SAN MIGUEL SUBDIVISION (UNITS 1, 2, & 3) P.U.D. / M.D.P. PLAN

Re: San Miguel Subdivision, Units 1,2, & 3

MDP # 427-H

**City of San Antonio
Planning Department
Master Development Plan Section
REQUEST FOR REVIEW**

ENTRANCE DETAIL
1"=50'

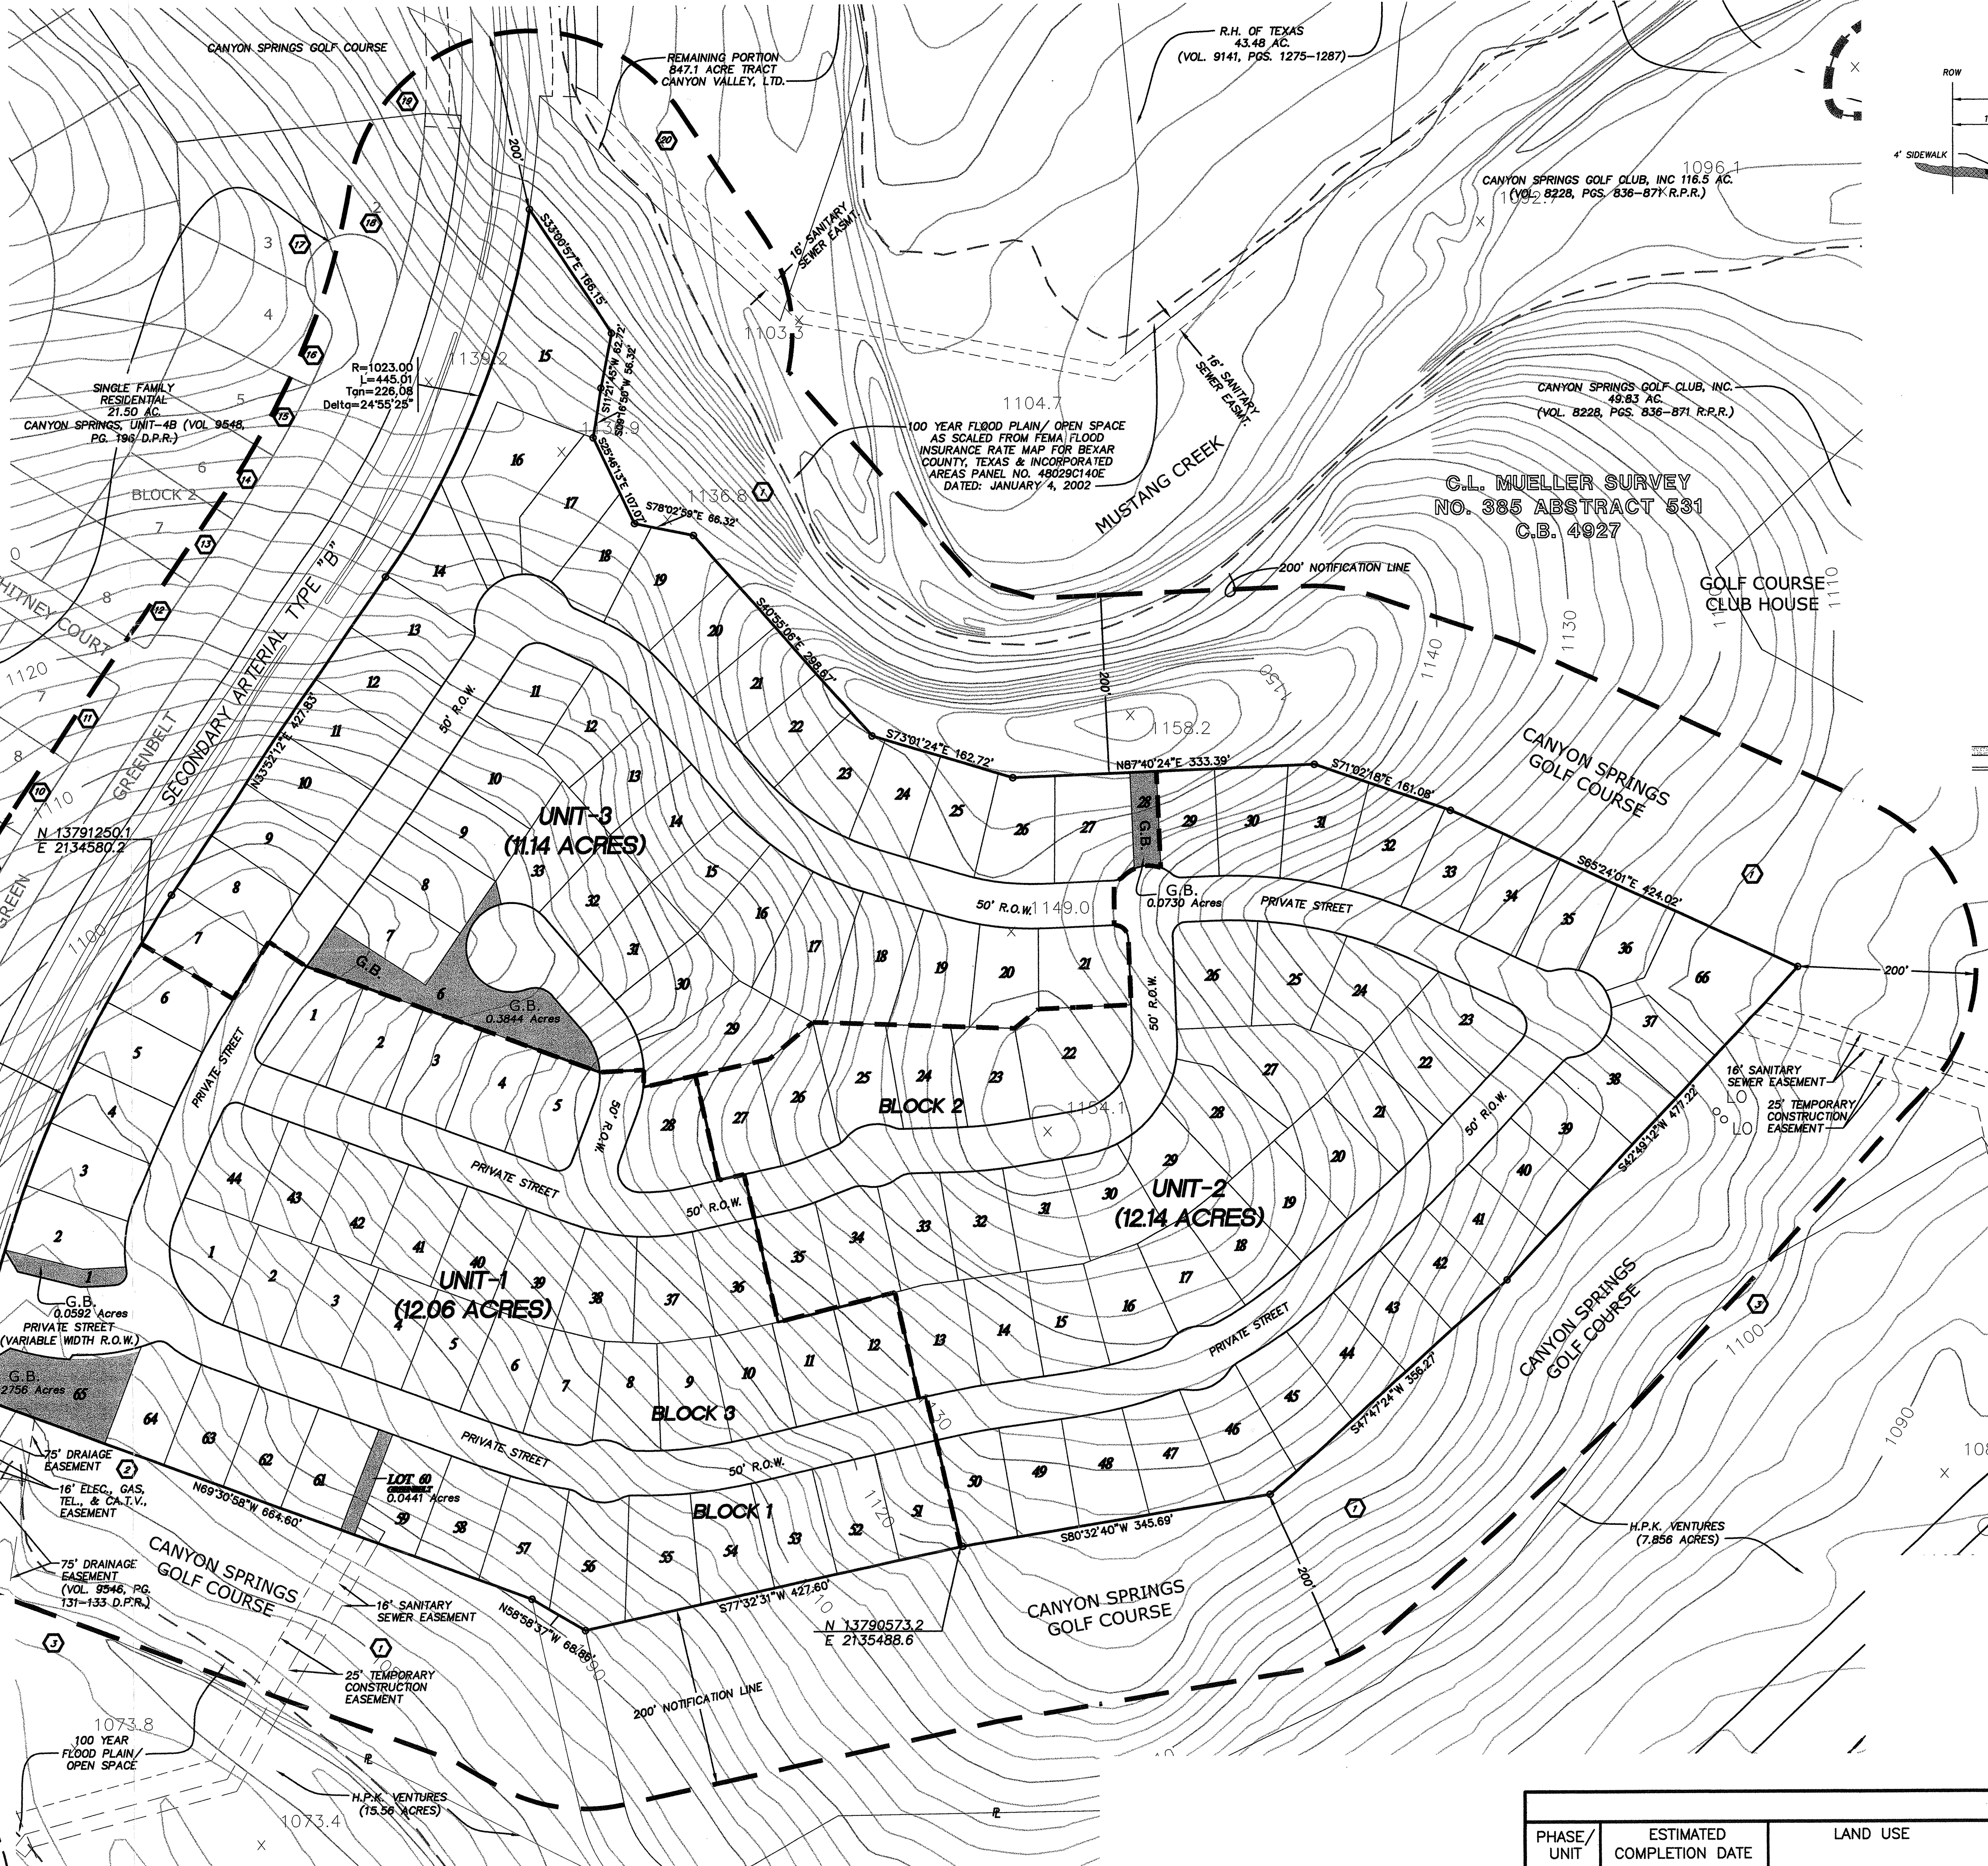
Comments: Please submit sidewalk or pedestrian
access plans inclusive of entrance detail.
